ADDENDUM 2

PROJECT NAME: Texas A&M University Area Streets

DATE: January 15, 2025

PROJECT NO: 23-03921

Figure 1-43 Schematics of Concrete Washout Areas

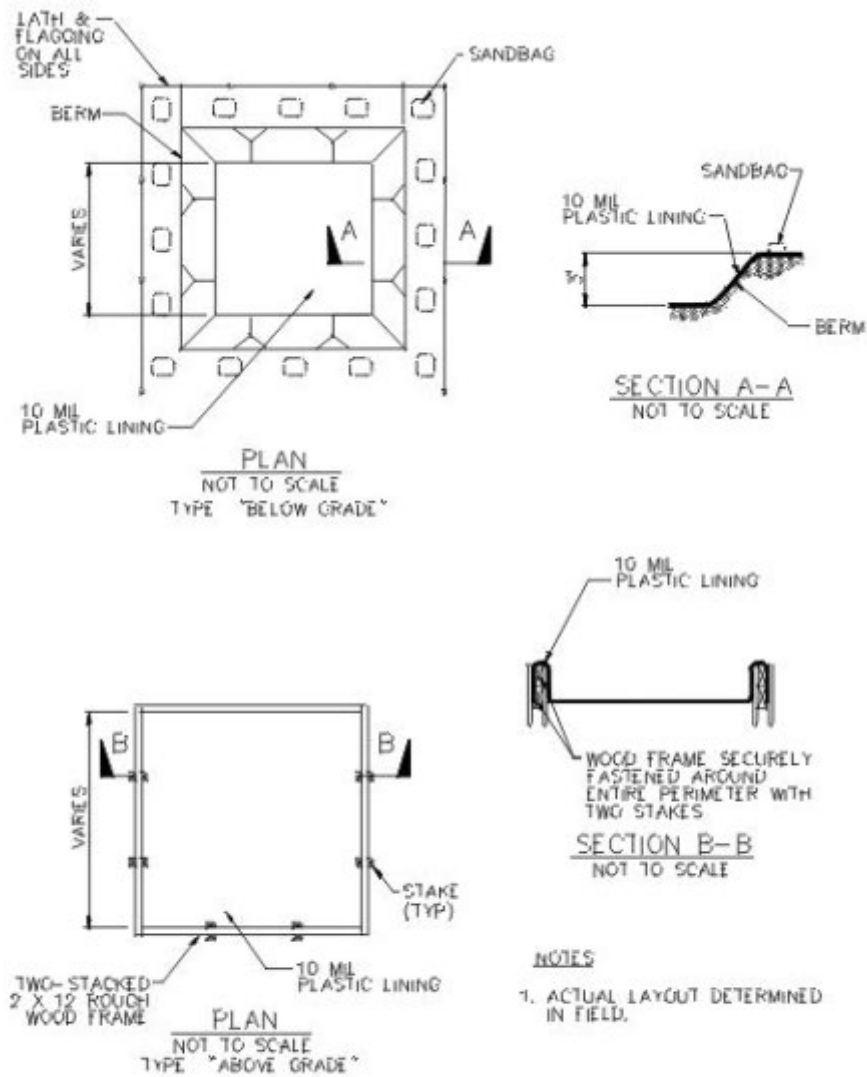
1. PROVIDED MISCELLANEOUS SPECIFICATION FOR CONCRETE WASHOUT PIT

Below grade concrete washout facilities are typical. These consist of a lined excavation sufficiently large to hold expected volume of washout material. Above grade facilities are used if excavation is not practical. Temporary concrete washout facility (type above grade) should be constructed as shown on the details at the end of this section, with sufficient quantity and volume to contain all liquid and concrete waste generated by washout operations. Plastic lining material should be a minimum of 10 mil in polyethylene sheeting and should be free of holes, tears, or other defects that compromise the impermeability of the material.
